1. Type of Well: Oil Well	Gas Well 🛛 Other		8. Well Number	854H	
2. Name of Operator			9. OGRID Number	14744	
Mewbourne Oil Company			9. OOKID Nullioer	14/44

## SANDLOT 9/8 FEE #823H

Operator:	OGRID:
MEWBOURNE OIL CO	14744
P.O. Box 5270	Action Number:
Hobbs, NM 88241	465650
	Action Type:
	[C-103] NOI Change of Plans (C-103A)

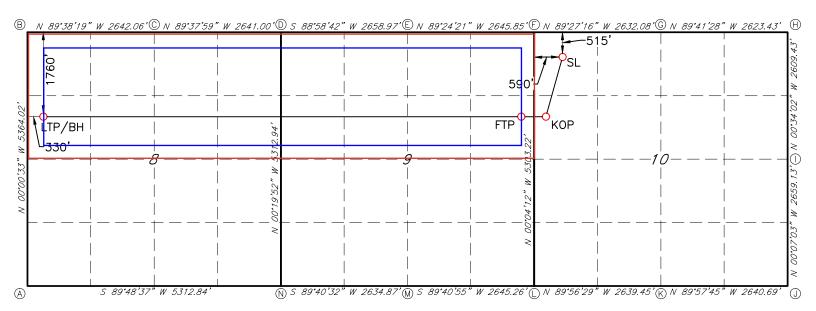
CLOSED-LOOP SYSTEM OTHER: 13. Describe proposed or comp of starting any proposed we proposed completion or rec Mewbourne Oil Company requests t 1. Change well name f/ Sandl 2. Change SHL f/ 315 FNL & 3. Change BHL f/ 1980 FNL 4. Attached New C102 reflect Spud Date: 6/15/25	leted operations. (Clearly state all p ork). SEE RULE 19.15.7.14 NMAC completion. that the following changes be made t ot 9/8 Fee #854H to Sandlot 9/8 Fee 760 FWL (10) to 515 FNL & 590 F & 330 FWL (8) to 1760 FNL & 330 ting these changes. Rig Release Da	te: 8/15/25	npletions: Attach wel ee #854H well (API #	lbore diagram of	
CLOSED-LOOP SYSTEM OTHER: 13. Describe proposed or comp of starting any proposed we proposed completion or rec Mewbourne Oil Company requests t 1. Change well name f/ Sandl 2. Change SHL f/ 315 FNL & 3. Change BHL f/ 1980 FNL + 4. Attached New C102 reflect	leted operations. (Clearly state all p ork). SEE RULE 19.15.7.14 NMAC completion. that the following changes be made t ot 9/8 Fee #854H to Sandlot 9/8 Fee 760 FWL (10) to 515 FNL & 590 F & 330 FWL (8) to 1760 FNL & 330 ting these changes.	te: 8/15/25	npletions: Attach wel ee #854H well (API #	lbore diagram of

<u>SURFACE LOCATION (SL)</u> 515' FNL & 590' FWL (SEC.10) N: 514124.0 - E: 587422.8

<u>KICK OFF POINT (KOP)</u> <u>1760' FNL & 243' FWL (SEC.10)</u> N: 512882.7 – E: 587078.4

FIRST TAKE POINT (FTP) <u>1760' FNL & 330' FEL (SEC.9)</u> N: 512888.4 – E: 586505.6

LAST TAKE POINT/BOTTOM HOLE (LTP/BH) 1760' FNL & 330' FWL (SEC.8) N: 512896.5 - E: 576578.8
